UO EMU: City of Eugene Predev. Conf Questions

March 13, 2012

Re: University of Oregon EMU Building Expansion

CENTRAL SPACE APPROACH: SHAFT

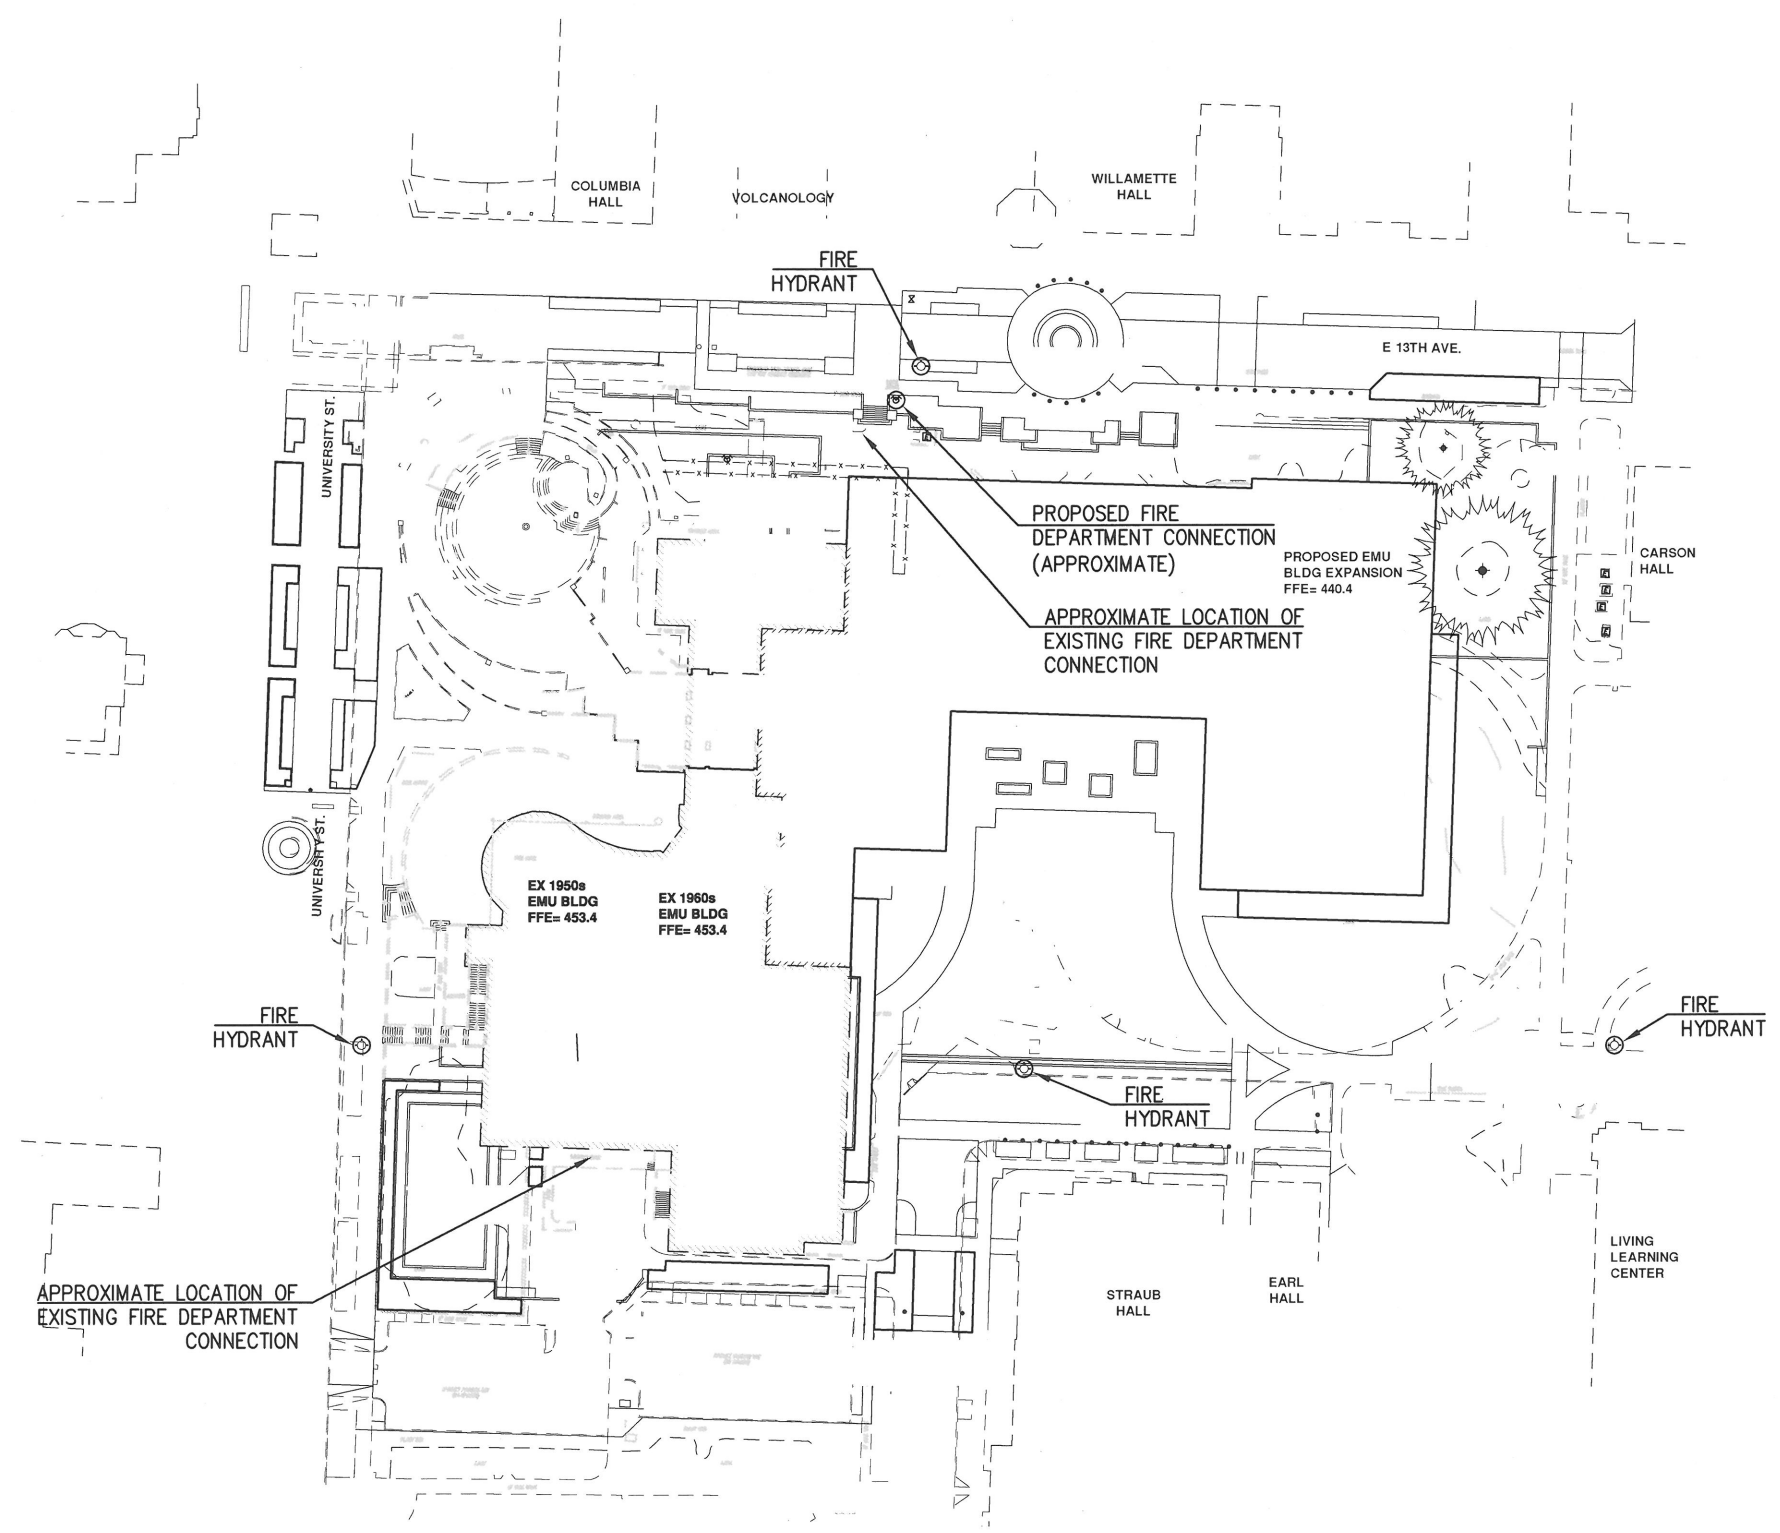
8	7 Building Codes	Nathan Burton	The entire building, both new & existing are proposed to be fully sprinklered per NFPA 13. The proposed central space in the new addition is three stories tall. The design will use a shaft approach to limit the number of connected stories to two, by providing a 2-hour rating at all third-floor walls that face the central space. This will include a combination of traditional rated wall & door construction as well as rated glass assemblies with sprinkler curtain protection and roll-down doors or curtains. Please verify that this approach is acceptable.	
9	8 Building Codes	Nathan Burton	Would glass elevator enclosures be acceptable within the above described central space?	
10	9 Building Codes	Nathan Burton	Multiple means of egress are provided from every major area of the new & existing buildings. Some areas will utilize an open stair in the central space as one of those means, with at least one other provided as an enclosed and rated stairwell. Please verify that this is an acceptable approach.

1. Confirm creating a 2 hour rated separation, like a shaft, in the 3 story open space conforms to Section 404.5, exception for smoke control requirements in the open space.
2. Discuss fire department aerial apparatus access requirements, reference attached diagram.
3. Discuss differences in stage versus platform in auditorium/performance space.
4. Review fire hydrant layout for conformance to requirements.
5. Review modifications to Mill Center structural system can be done without triggering seismic upgrade requirement.
6. Review egress system in existing building and proposed addition.
7. Review crowd management criteria to maintain Section 1028.2 and 1028.4 requirements.
8. Review approach of energy code conformance to new and existing buildings.
